Riverfront Phase IIB Fort Wayne, IN

ADDENDUM #1

October 7, 2024

ADDENDUM NO. 1

3.4 FIELD QUALITY CONTROL

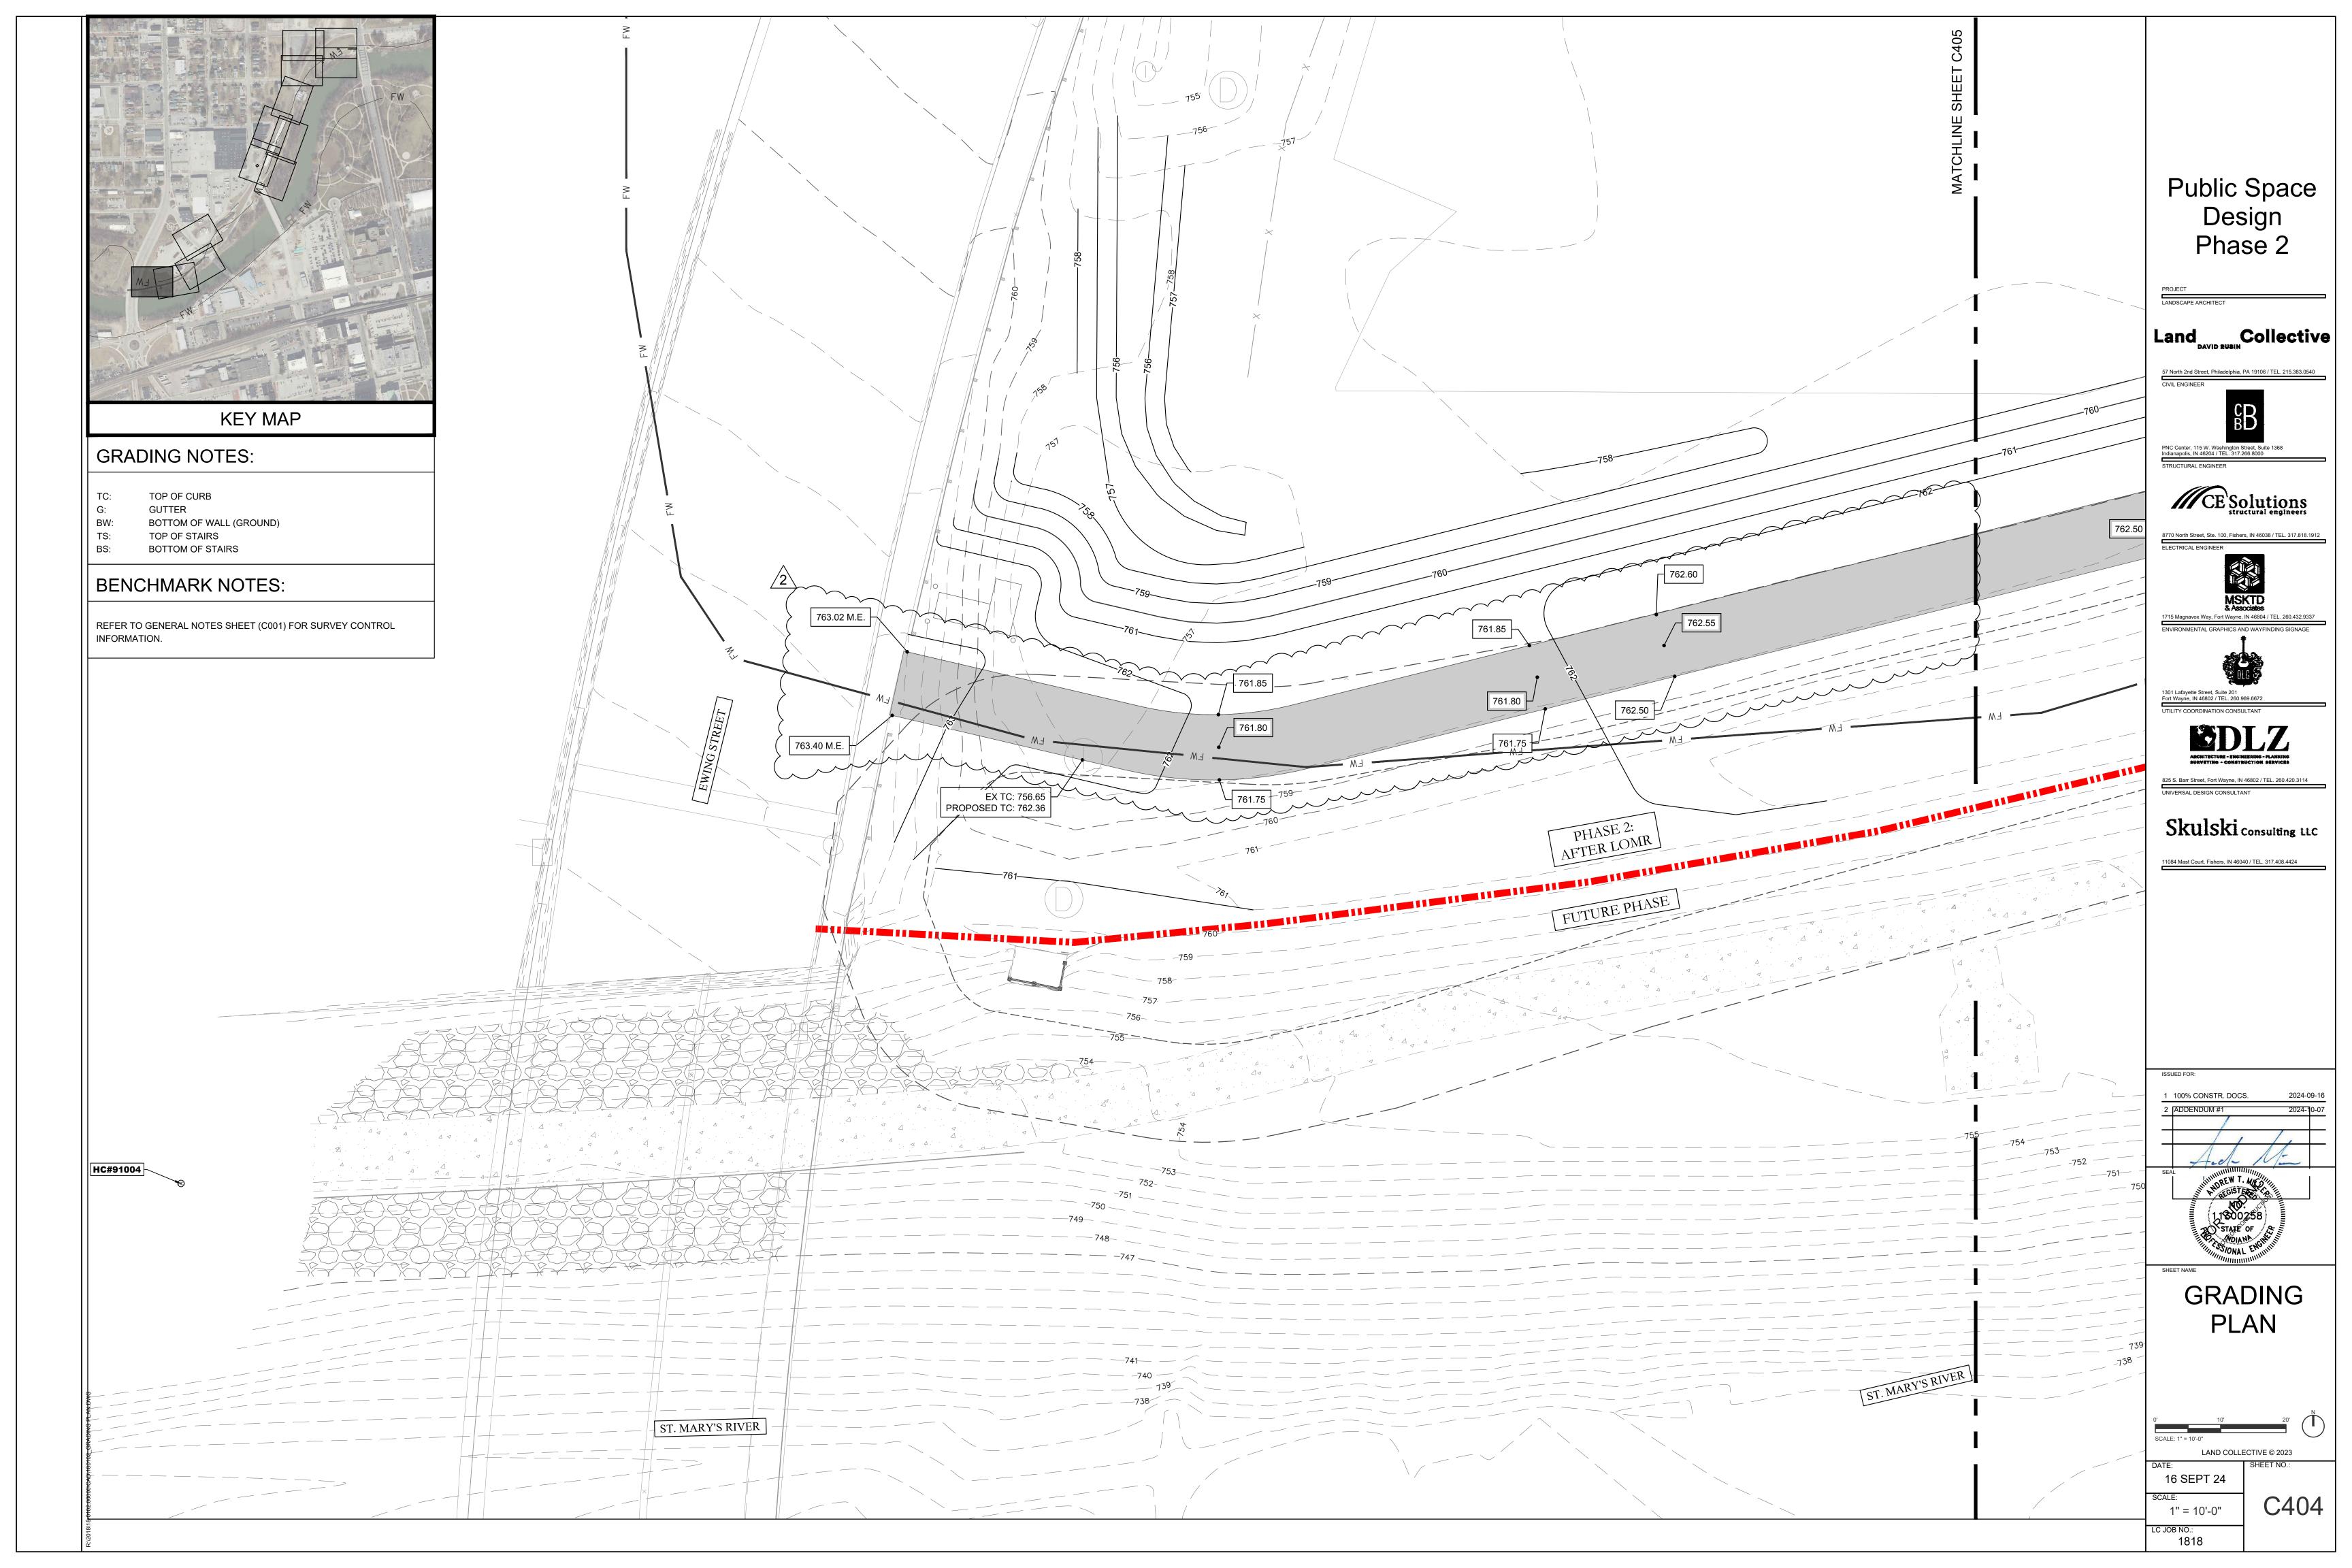
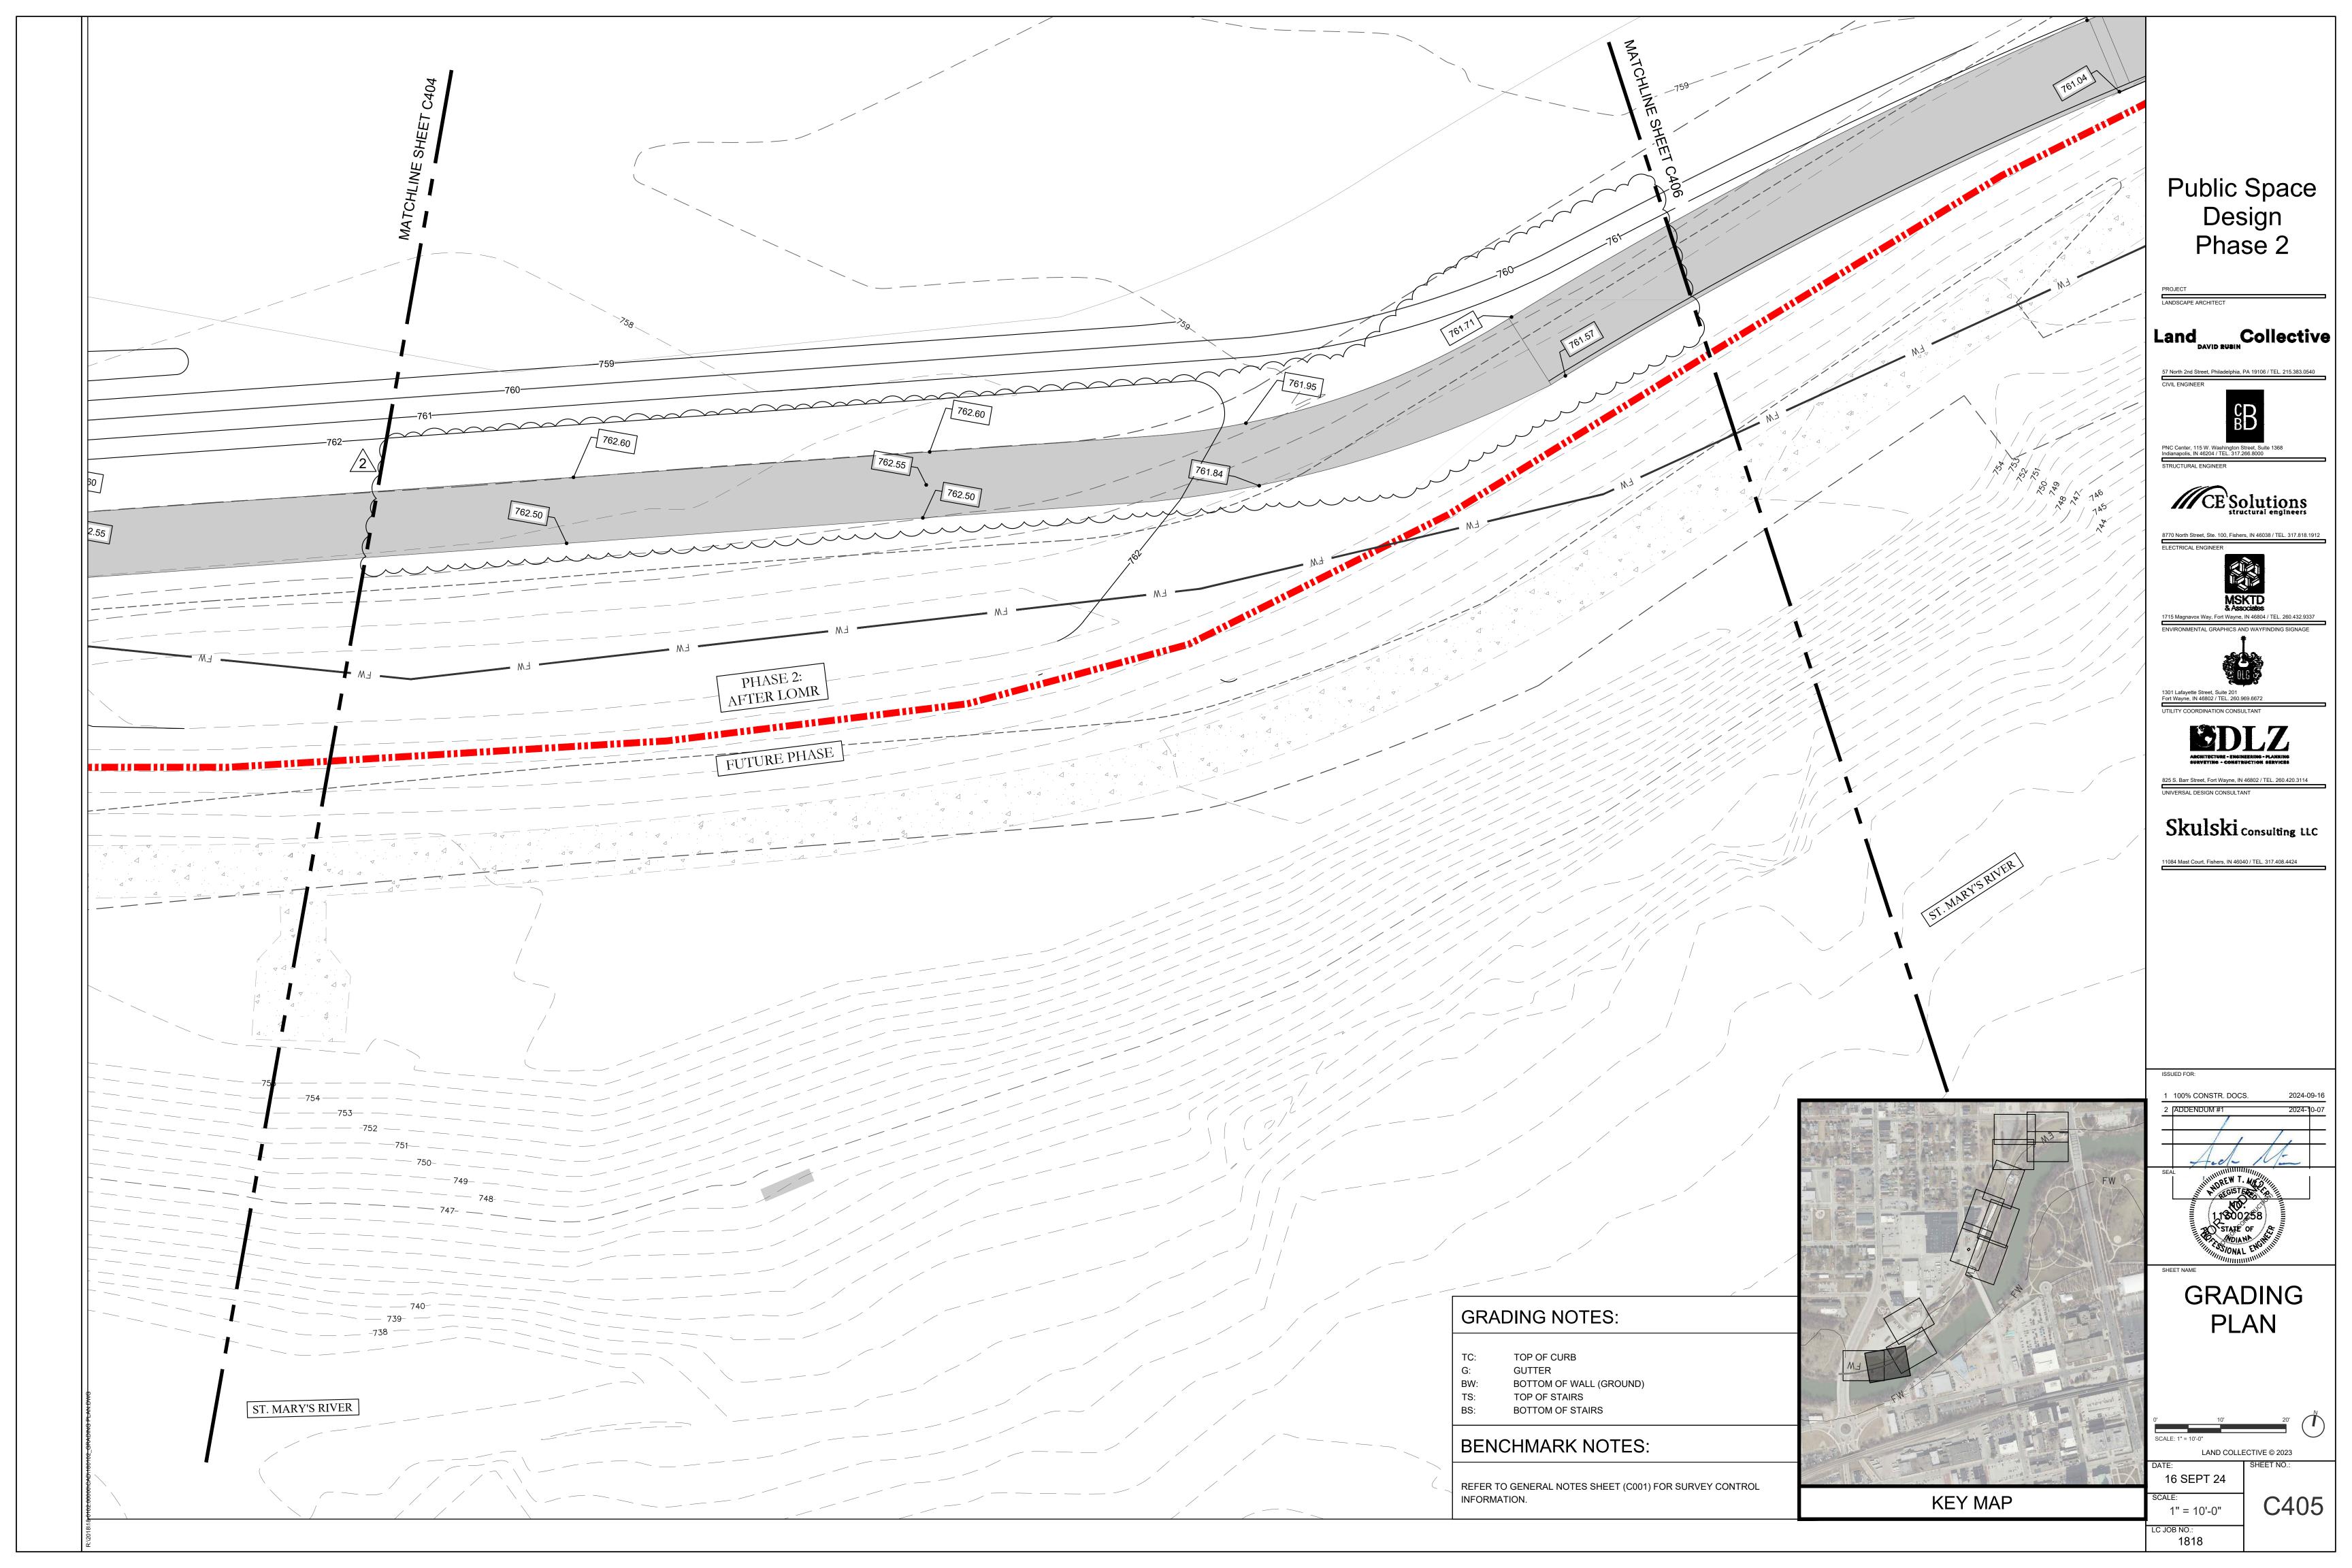
C606 - Miscellaneous Details

- Added Detail #2 Removable Bollard
- Added Detail #3 Trail Connection at Ewing Street
